MILITARY SPECIFICATION

SWITCHING GROUP, RF, AN/UPA-61( )

This amendment forms a part of Military Specification MIL-S-28738C(EC) dated 15 May 1975.

FIGURE 5. Test diagram for Leakage current.

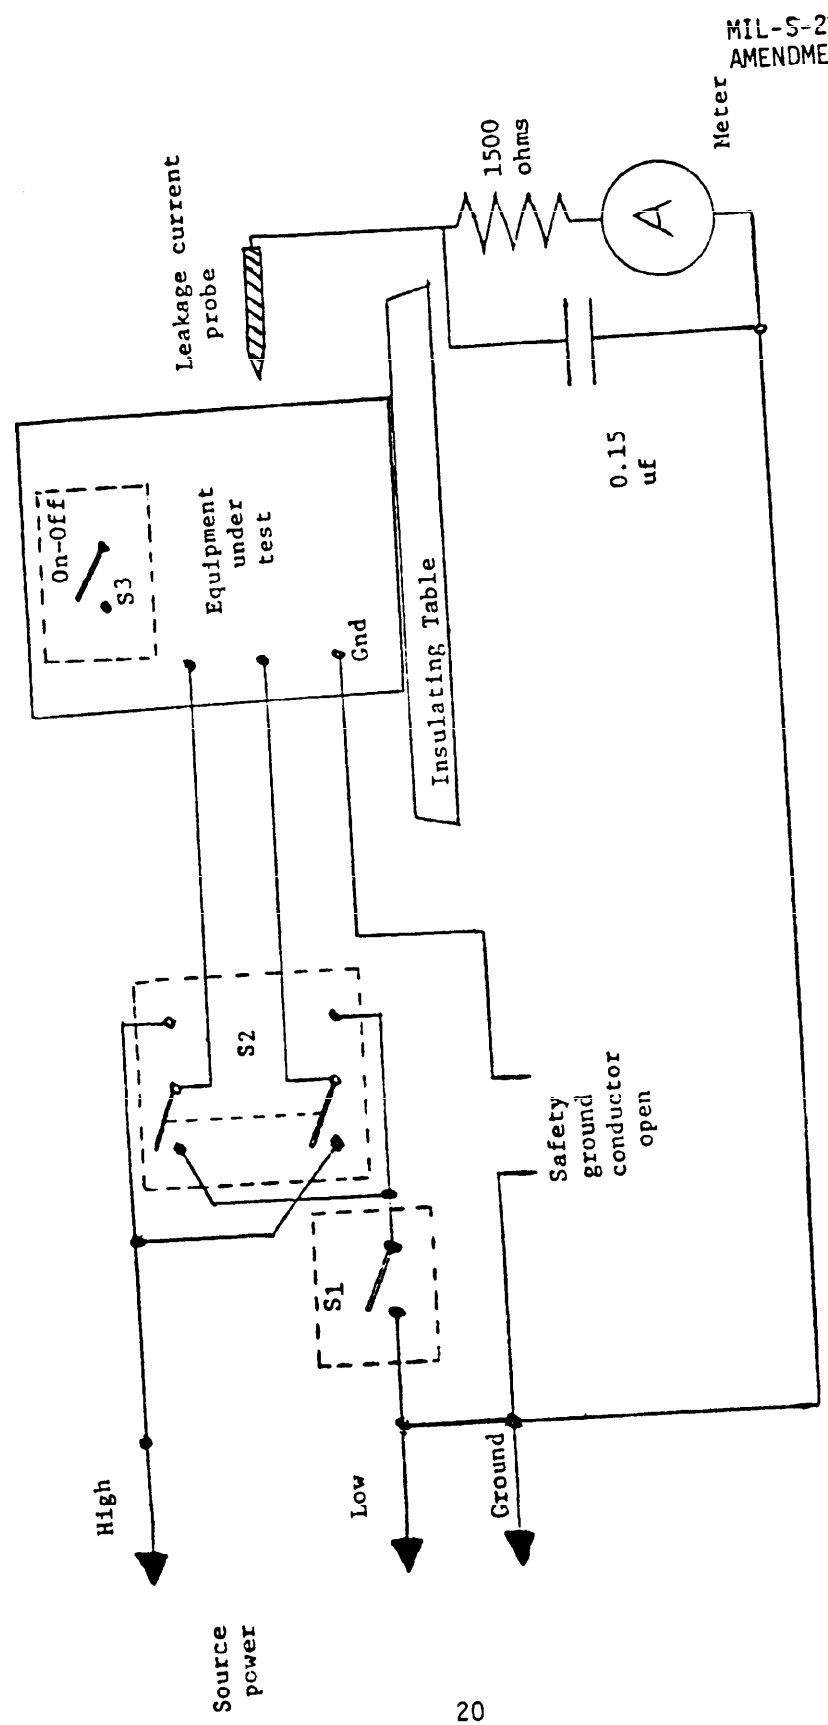
After 4.5.14 add new paragraph 4.5.15 as follows:

"4.5.15 Leakage current measurement. Leakage current, as part of the safety criteria of the AIMS RF Switching Group, shall be measured in the following manner. Each equipment shall be placed on an insulated surface and test connections made as shown in the Test Diagram for Leakage Current, FIGURE 5. The ground connection between the equipment and the safety ground conductor shall be opened. The equipment shall be operated with nominal input voltage and frequency. The probe shall be connected to the equipment enclosure and the leakage current measured for every combination of switch positions available in the test diagram. All parts not electrically common with the equipment enclosure shall also be tested for leakage current. Equipments having more than one mode of operation, such as transmit and receive, shall be tested in each mode."

After page 19, add new Figure 5 as page 20.
